# ADDENDUM #1

**Date:** August 8, 2019  
**City of Brookhaven RFP No.** RFQ 19-315  
**Project Name:** Briarwood Park Pool Project

**This addendum includes project clarifications, plan revisions due to permitting reviews, and responses to questions received by the Deadline for Questions (August 6, 2019 at 12:00 (noon) EST), .**

BID/PERMIT SET	
SHEET TITLE	
FOUNDATION PLAN

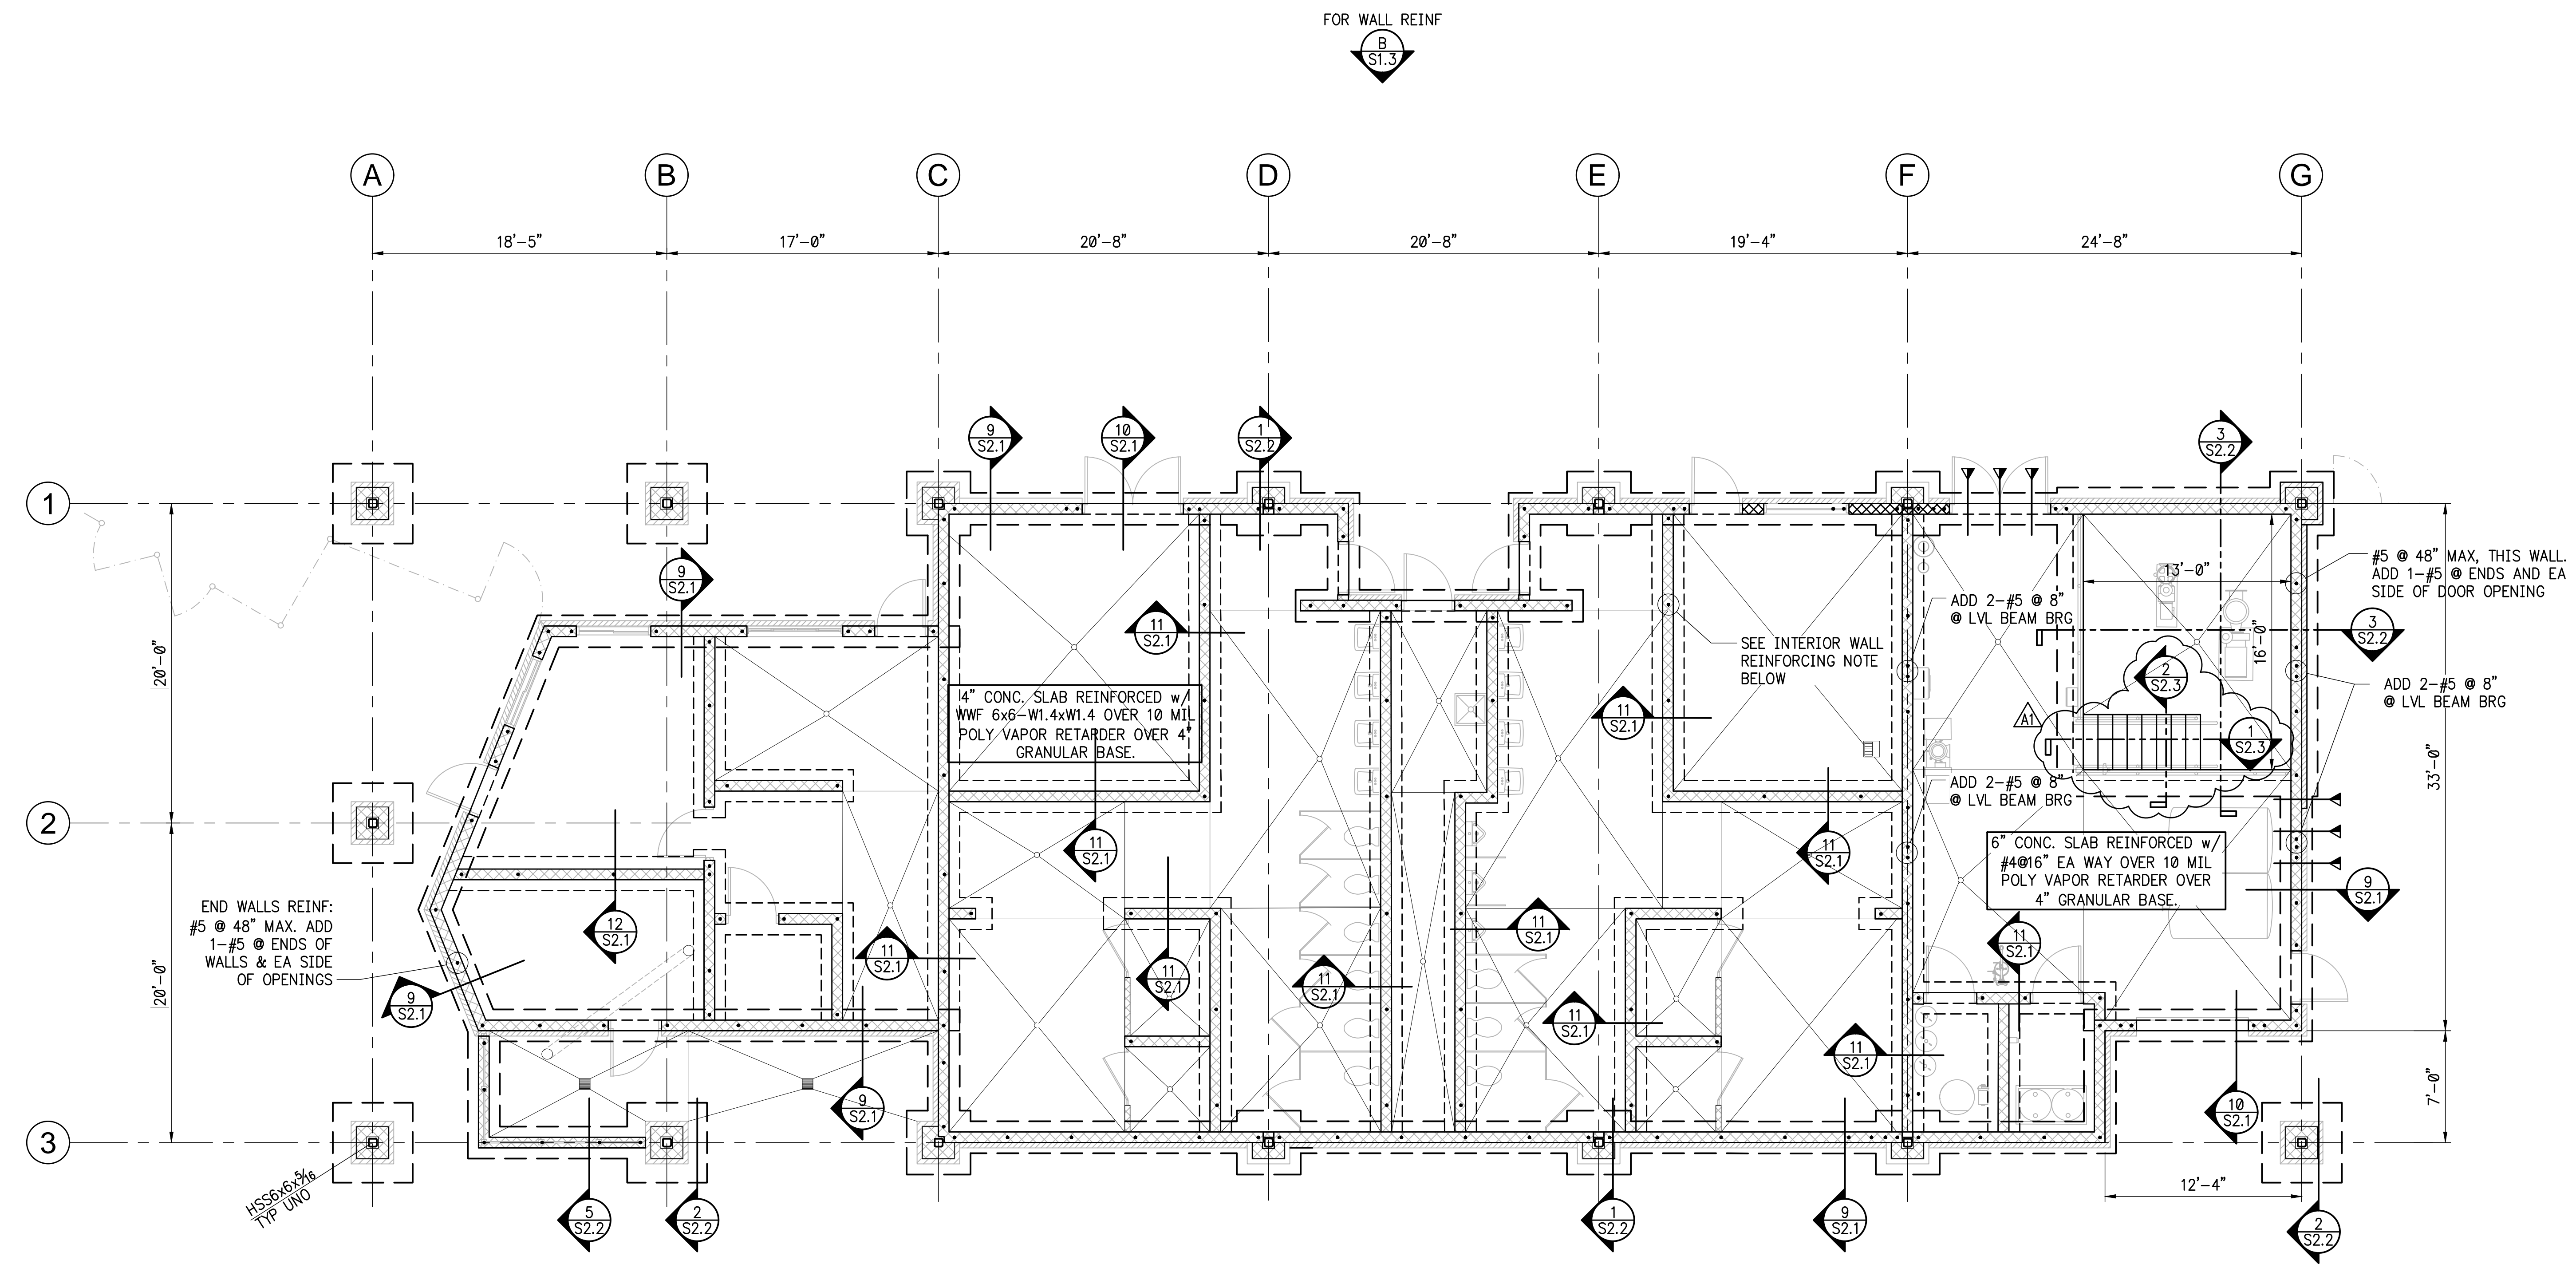
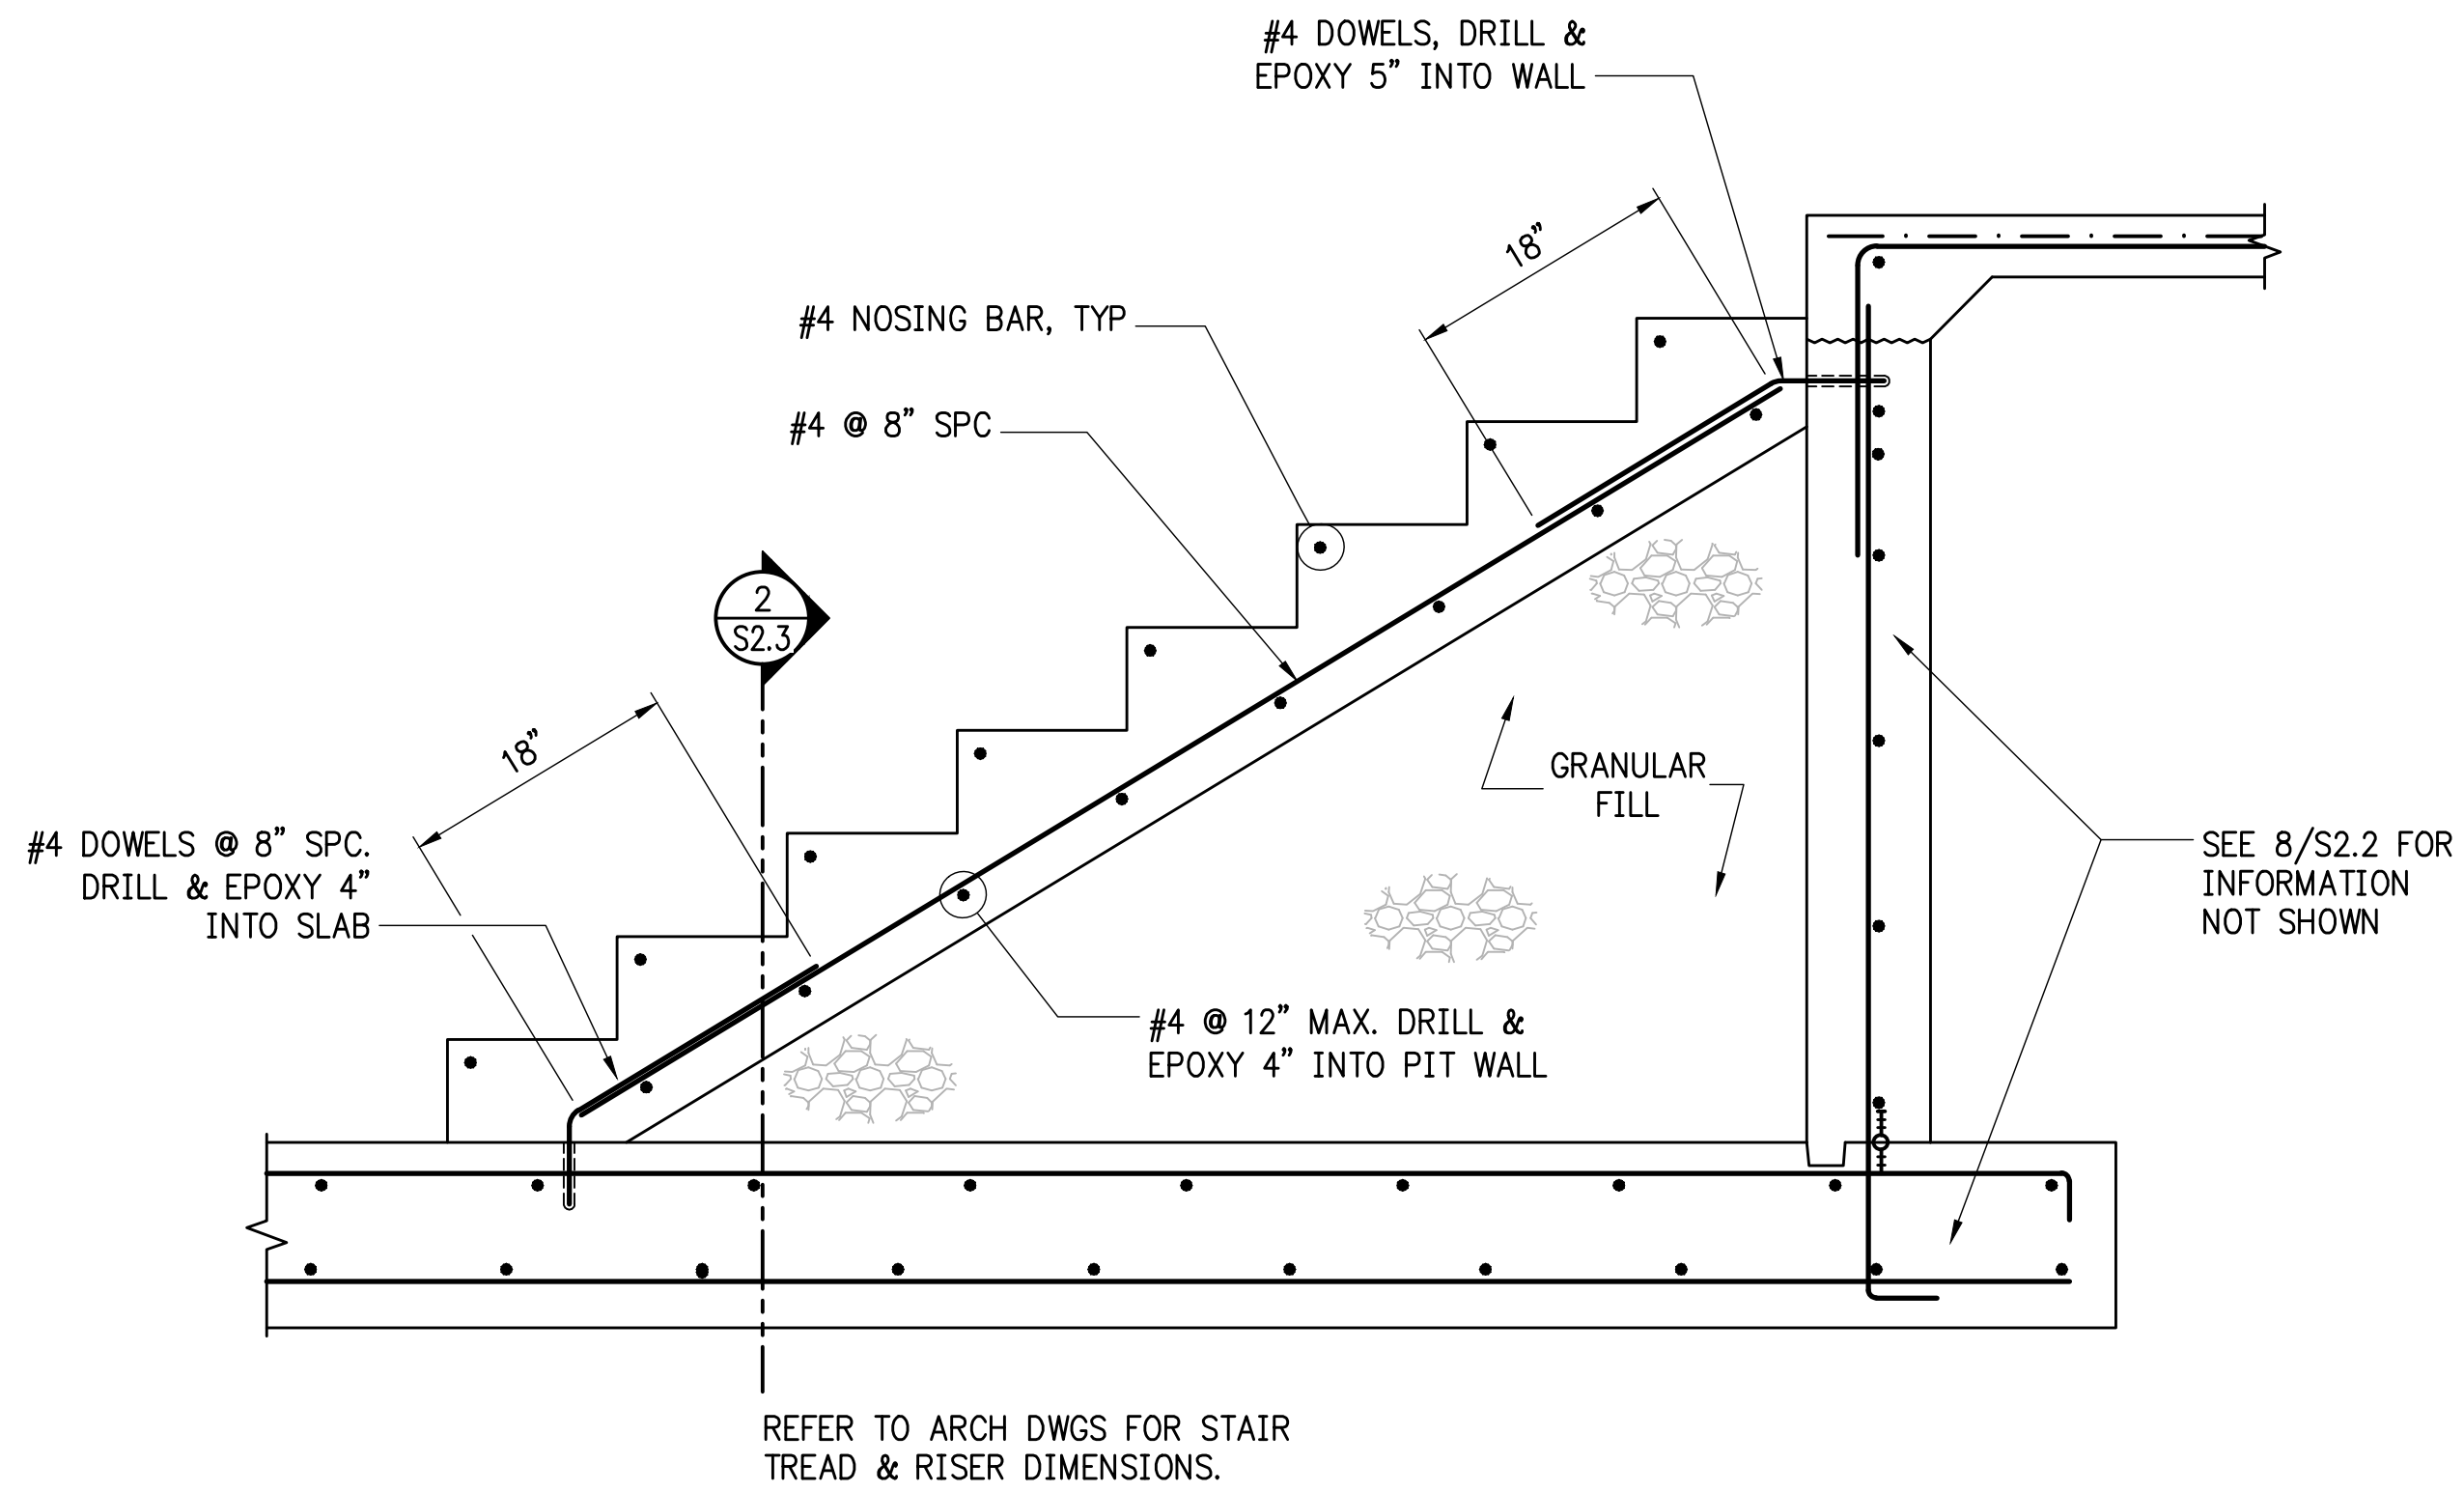
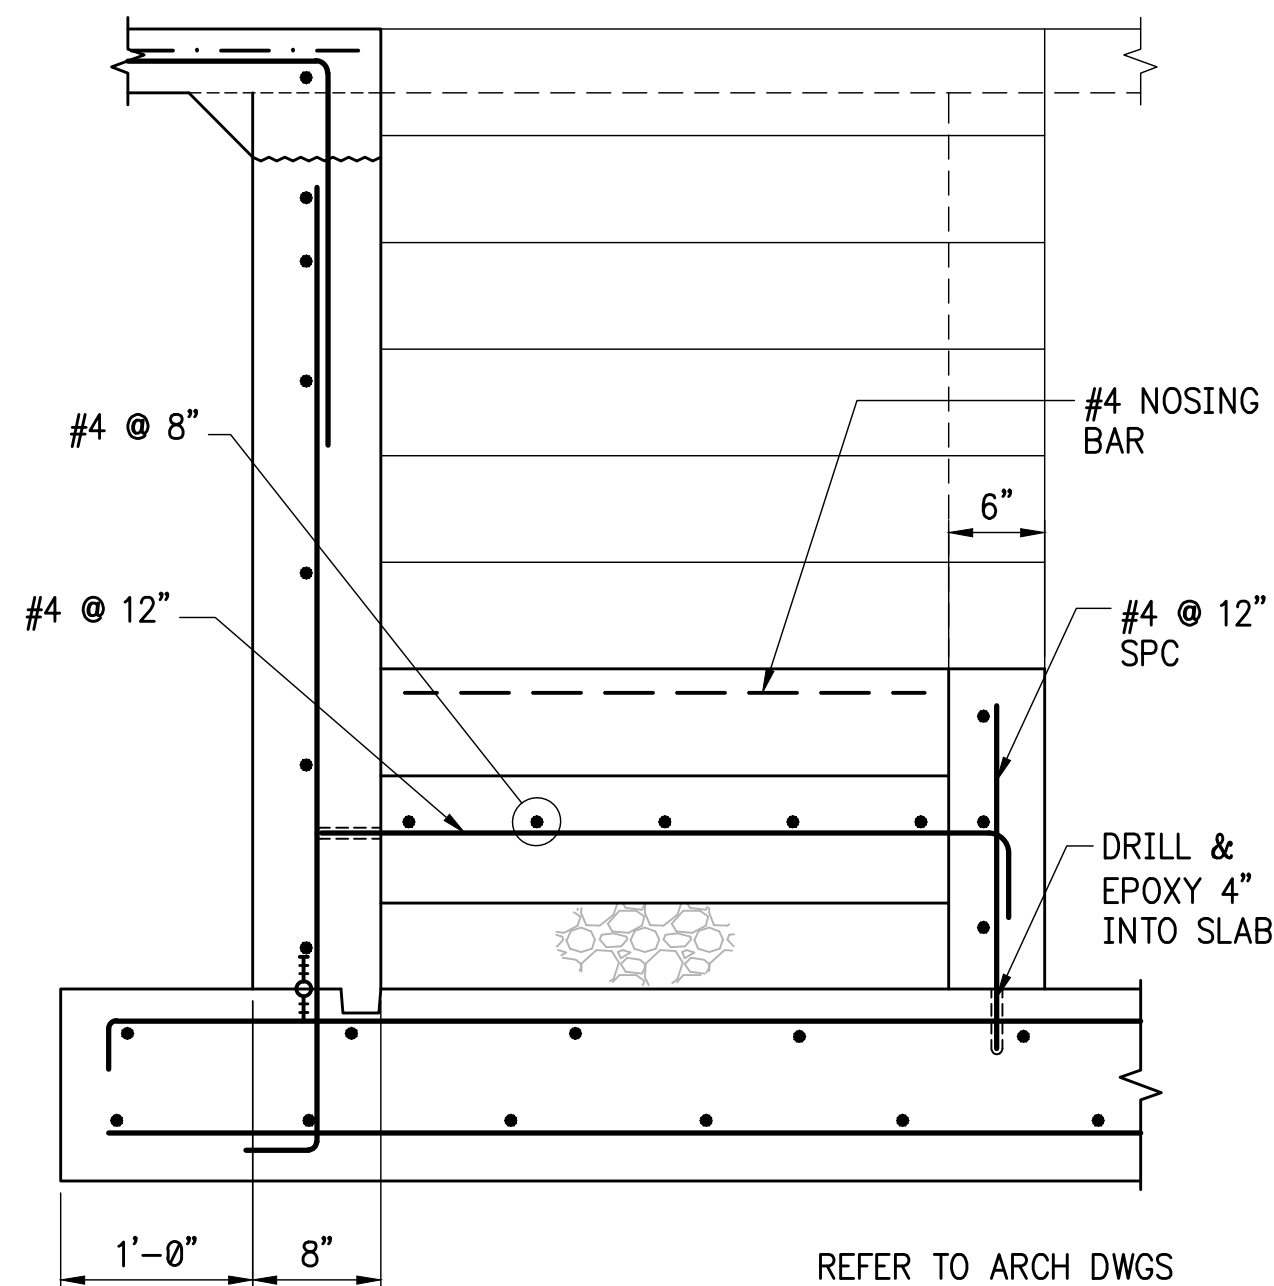
4. SHEET S1.1 – FOUNDATION PLAN: Revised to provide detail and section call outs for stairs into pump pit.
5. SHEET S2.3 – PIT STAIR SECTIONS AND DETAILS: New sheet adding information for stairs into pump pit.
6. SHEET C4.03 – SITE DETAILS: note added to Detail 3 identifying umbrella size as 7' – 6" Diameter.
7. SHEET C4.03 – SITE DETAILS: note added to Detail 7 identifying the pavilion size as 24' Diameter.

26. Is there a detail for the concrete stairs in the pool pit area? What type of nosing required.
    - a. *Refer to revised sheet S1.1 – FOUNDATION PLAN and new sheet S2.3 PIT STAIR SECTIONS AND DETAILS.*

**E1.0**

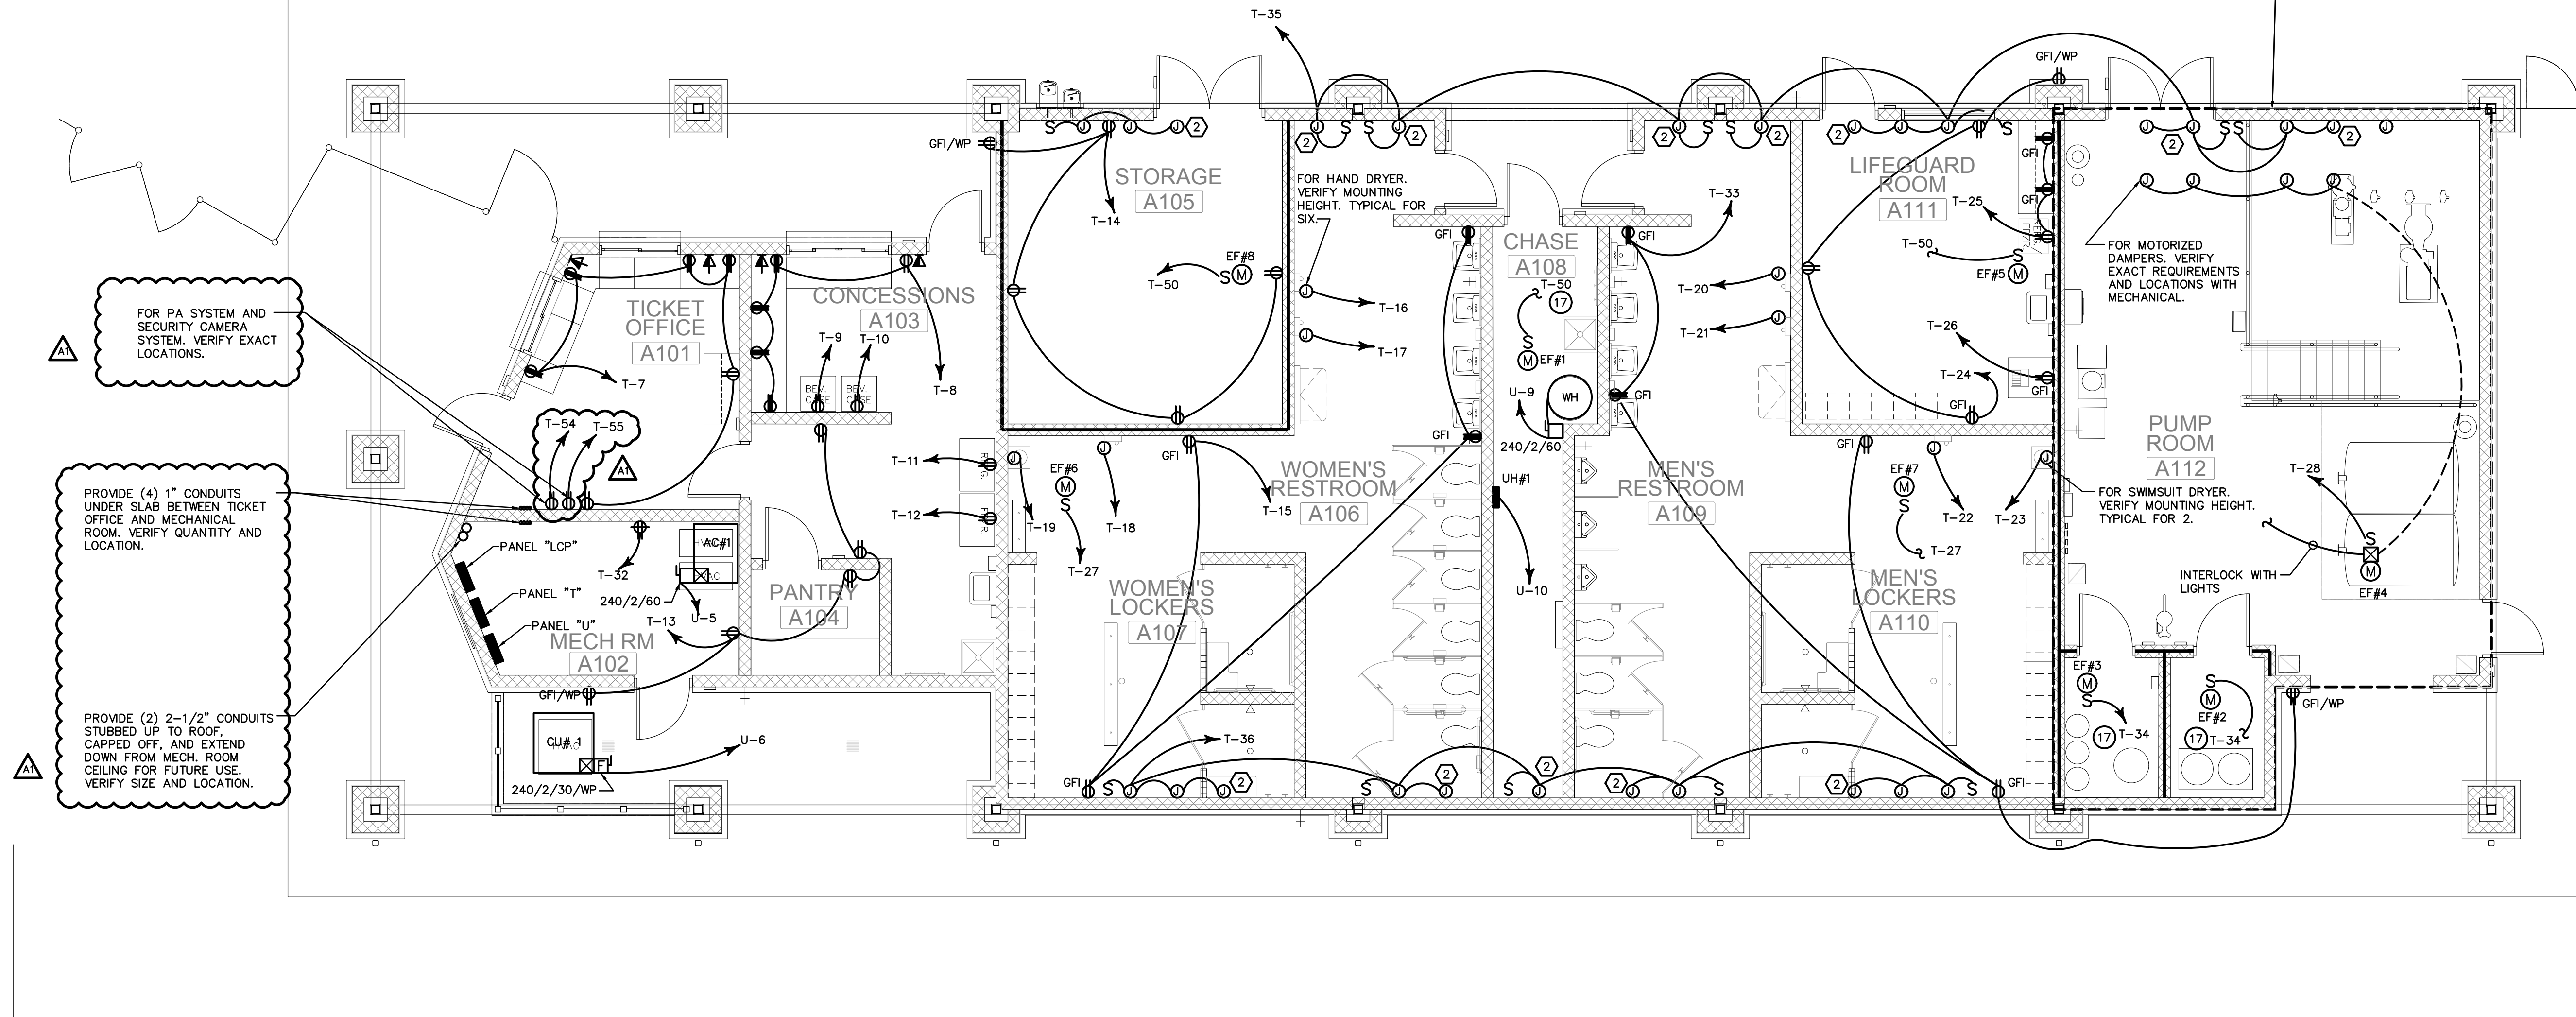
2. The following sheets are to be removed and replaced due to revisions showing additional conduit for a Camera and PA system, and a revision to the light pole locations. The revised sheets are clouded and noted with **A1 – 08/08/2019 – ADDENDUM 1 REVISIONS**
  - a. E1.0 – SITE ELECTRICAL PLAN
  - b. E2.1 – POWER PLAN
  - c. E3.0 – ELECTRICAL LEGEND, NOTES, SCHEDULES
